Change The following graphic is a modification of Figure 5-18 and replaces that figure:

5.1.6.8 Century City Santa Monica Station

Figure A-1. Existing Plus Project Level-of-Service

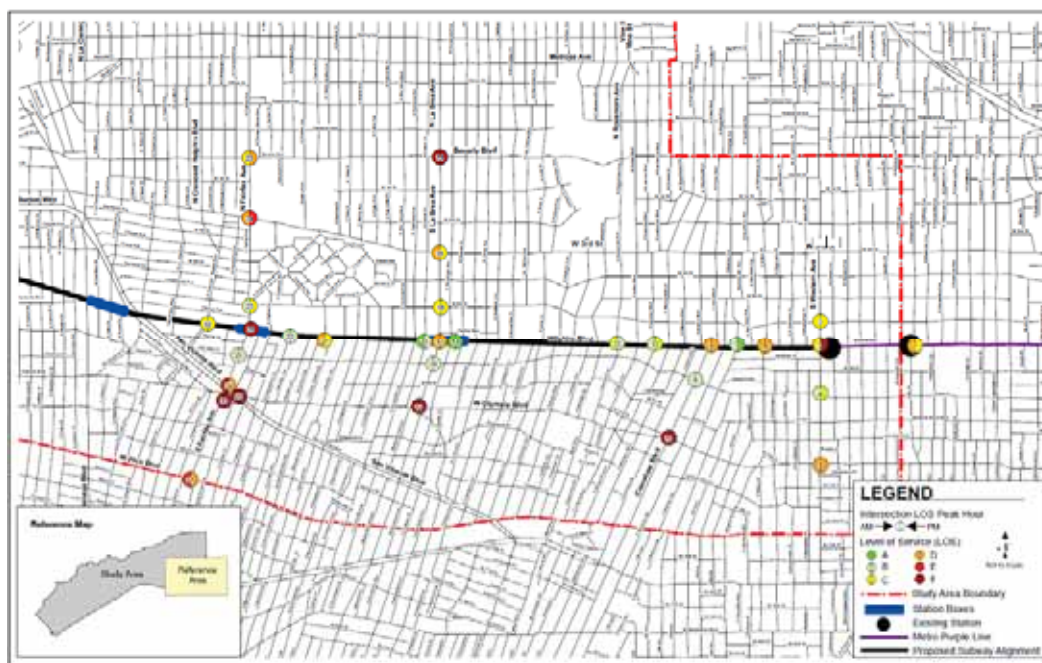
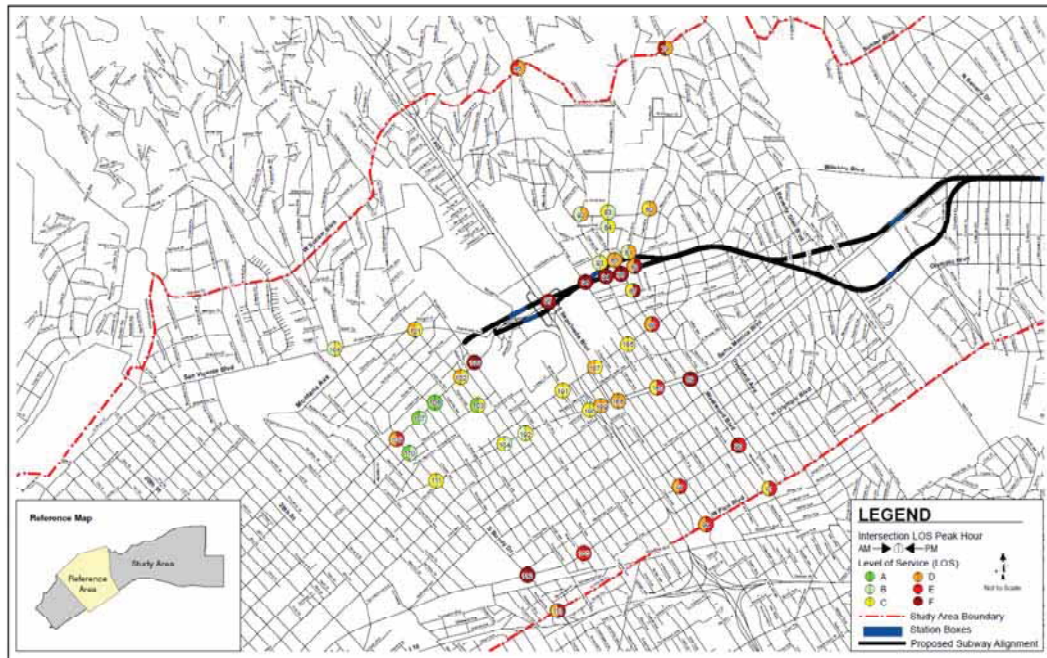
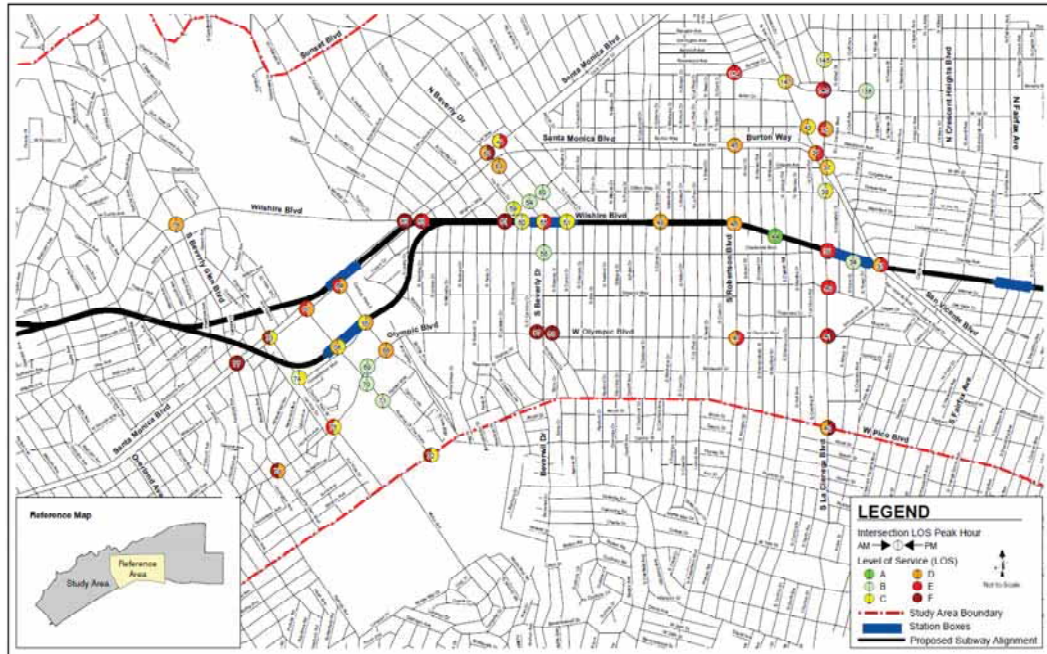
Add The following supplements the traffic impact analysis and is added to the section to assess impacts resulting from an Existing plus Project scenario. Figure A-1 and Table A-3 are added to this section.

Under Existing plus Project conditions, 89 of the 126 analyzed intersections (71 percent) will operate at an acceptable LOS D or better in the morning peak hour. The remaining 37 intersections (29 percent) will operate at LOS E or F (deficient LOS) during the AM peak hour. Eighty two of the 126 analyzed intersections (65 percent) will operate at an acceptable LOS D or better in the PM peak hour. The remaining 44 intersections (35 percent) will operate at LOS E or F (deficient LOS) during the PM peak hour. The LOS results by peak hour are illustrated graphically in Figure A-1.

Figure A-2. Beverly Drive Lane Configurations with Bank of America Portal Option

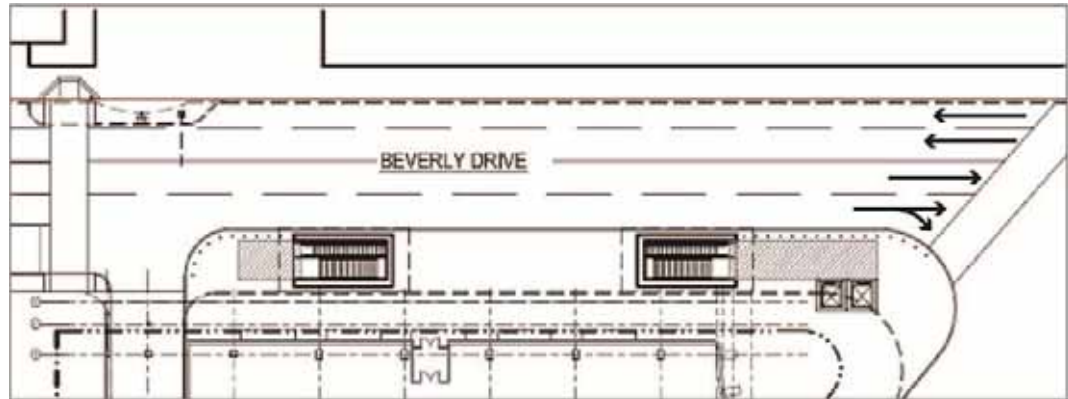
The following supplements the traffic impact analysis and is added to the section to assess impacts resulting from the Bank of America portal option for the Wilshire/Rodeo Station. Figures A-2 through A-4 and Tables A-4 and A-5 are added to this section.

The Bank of America portal option would result in reduced vehicular capacity at the south approach of Beverly Drive at Wilshire Boulevard. The location of this portal (northwest corner of Wilshire Boulevard and Beverly Drive) would require the following modifications to Beverly Drive between Dayton Way and Wilshire Boulevard:

- Widening the sidewalk on the western side by 15 feet
- Removal of the southbound right-turn lane
- Removal of three metered parking spaces and one loading zone space on the western (southbound travel direction) side
- Removal of up to 13 metered parking spaces on the eastern side (northbound travel direction) side
- Removal of the mid-block curb extension on the eastern side
- Removal of the mid-block northbound and southbound left-turn pockets

Southbound Beverly Drive at Wilshire Boulevard would be reduced from two through lanes and one right-turn lane to one through lane and one through-right lane (see Figure A-2).
